Community Development Department – Planning Division

REPORT TO PLANNING COMMISSION

SUBJECT: 5800 Northgate Drive (Northgate Town Square Project) – Study Session for the proposed Northgate Town Square Project (PLAN 21-039) (also referred to as the Northgate Mall Redevelopment Project), which includes requests for a Rezone to the Planned Development (PD) zone (ZC21-001) and an associated Development Plan, a Master Use Permit (UP21-007), an Environmental and Design Review Permit (ED21-024), a Vesting Tentative Map (TS21-002), State Density Bonus Law approvals including the provision of one concession/incentive to increase the permitted height to 78-feet for all buildings and structures in Phase 1 (2025) and Phase 2 (2040), and a Master Sign Program (SP24-002) to allow a comprehensive redevelopment of the existing mall at 5800 Northgate Drive into a phased mixed-use development with approximately 217,520 square feet of commercial space and 1,422 residential units on the 44.76-acre site. APNs: 175-060-12, -40, -59, -61, -66, and -67; General Commercial (GC) District, Merlone Geier Partners, LLC, owner/applicant of entire site. In addition to these entitlements, the applicant will also

Figure 6: Residential 1 Rendering (Original and Revised)

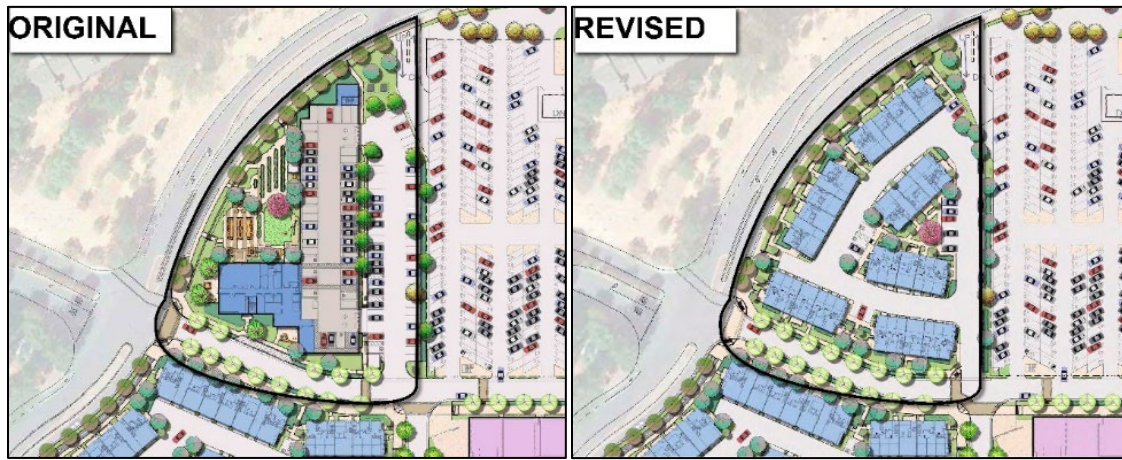
One of the most significant revisions to the overall project layout in the June 2024 submittal is the removal of the EAH affordable housing component on Residential 1 and the associated addition of 38 townhomes. This modification changed both the overall affordable housing programming as discussed below, but also resulted in a reduction in massing on Residential 1. These modifications were selected by the project applicant as an alternative approach to meeting the City's inclusionary housing requirements. Additionally, the applicant determined that the modifications would help address complexities associated with timing for project implementation. The elimination of the five story EAH building on Residential 1 also helped to address general

feedback concerned with the overall massing of the project, especially in relation to neighboring lower density residential uses.

The proposal for providing inclusionary housing as part of the revised project is a significant change from the previous proposal which had concentrated the required 10% low-income units as part of Phase 1 (96 units) into a single multi-family apartment building on Residential 1, to be built and operated by EAH.

Though not considered consensus items, comments from some members of both the Planning Commission and DRB expressed concern that the EAH building was not of similar design or quality as other residential buildings and that the approach did not appropriately distribute affordable housing throughout the site consistent with the City's requirements. Additionally, there were comments both from Planning Commission and DRB members and members of the public opposing the clustered approach to the provision of affordable housing within the project based on the City requirements to evenly distribute BMR units within a project, consistent with affordable housing guidelines adopted by the City Council through Resolution 14890 (Guidelines for the Administration of the Affordable Housing Requirement Program), on February 16, 2021 (the "Affordable Housing Guidelines"). Ultimately, the applicant elected to modify Residential 1 from apartments to townhomes, and to distribute inclusionary housing units across all residential buildings.

The applicant modified the proposal in the revised project to eliminate the EAH building on Residential 1, replacing the 96-unit apartment building with 38 three story townhomes that together with Residential 2 provide a total of 138 for-sale townhome units. To maintain the 1,422 units in the overall project, an additional 58 apartment units have been incorporated into the revised Residential 5. This modification resulted in architectural modification to Residential 5 to including an increase in building height from 5-stories to 6 stories.

Figure 8: Town Square (Original and Revised)

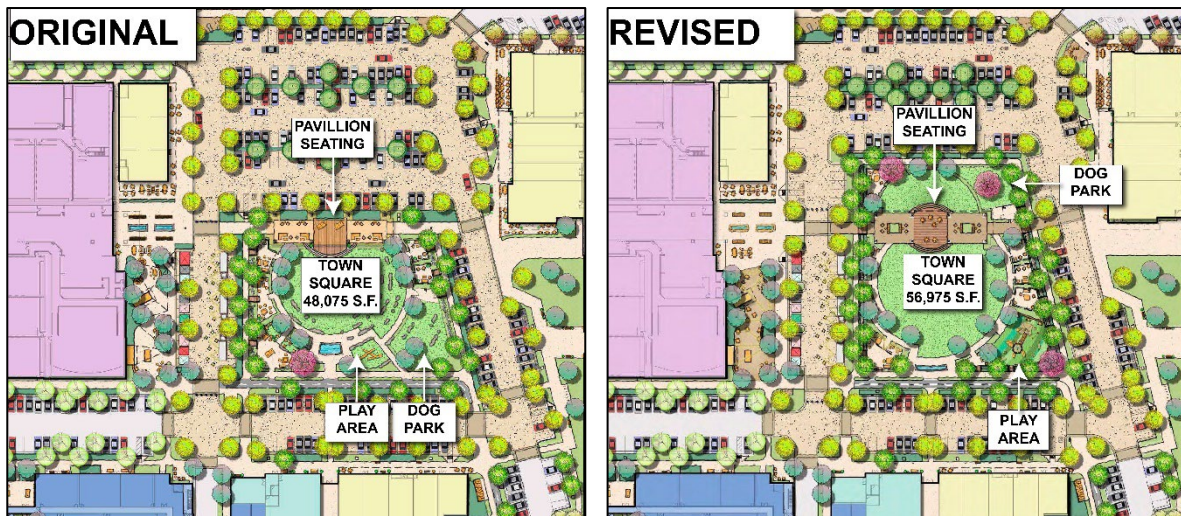
There were a number of comments from members of the public, DRB, and Planning Commission that were the focus of revisions to the Town Square. A common theme was the request for enlargement of this common amenity. Additional comments asked for inclusion of features for all

The revised project increased the size of the Town Square from 48,075 square feet to 56,975 square feet by incorporating a row of parking to the west of the Town Square. The applicant has committed to use of natural grass and eliminated the seating boulders in the lawn area to allow for more flexible use of the lawn area for activities. The dog park was relocated within the Town Square away from the children's play area but remains in the project based on market demands for the residential uses being introduced on the site. Modifications to landscaping in the Town Square better utilizes specimen trees for shading and interest.

Figure 10: Cinema Building (Original and Revised)

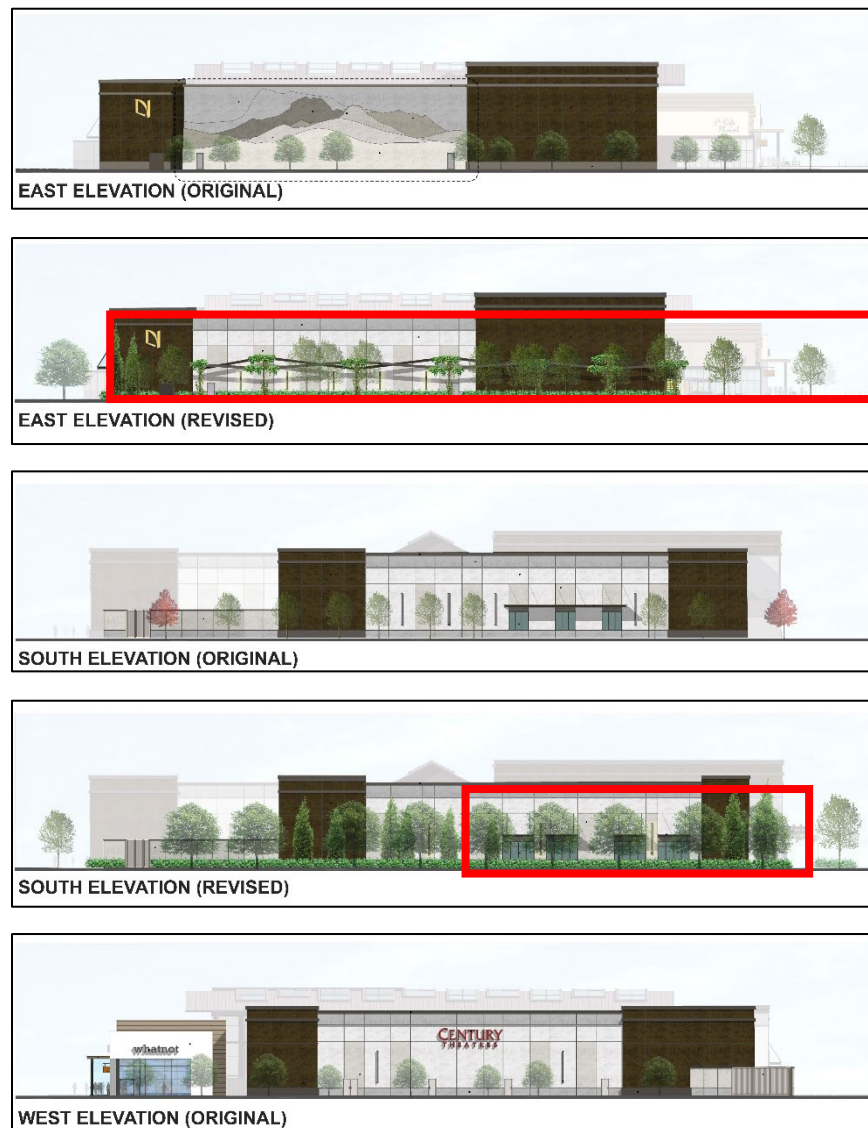
providing a landscaped green screen or other design solution to break up the rear façade of the cinema structure across from the town homes. In response to that feedback the revised project includes the following design modifications.

- Removal of the mountain relief feature on the east elevation
- Addition of a trellis and more robust tree planting along the east side of the building
- Addition of windows and sunshades on the south elevation, facing the townhomes
- Increased planting along the south elevation to further screen the elevation from the neighboring townhomes
- Increased landscaping along the west elevation to screen and provide relief from the large massing

These modifications are shown in the elevations in Figure 10 below and generally in the renderings in Figure 11.
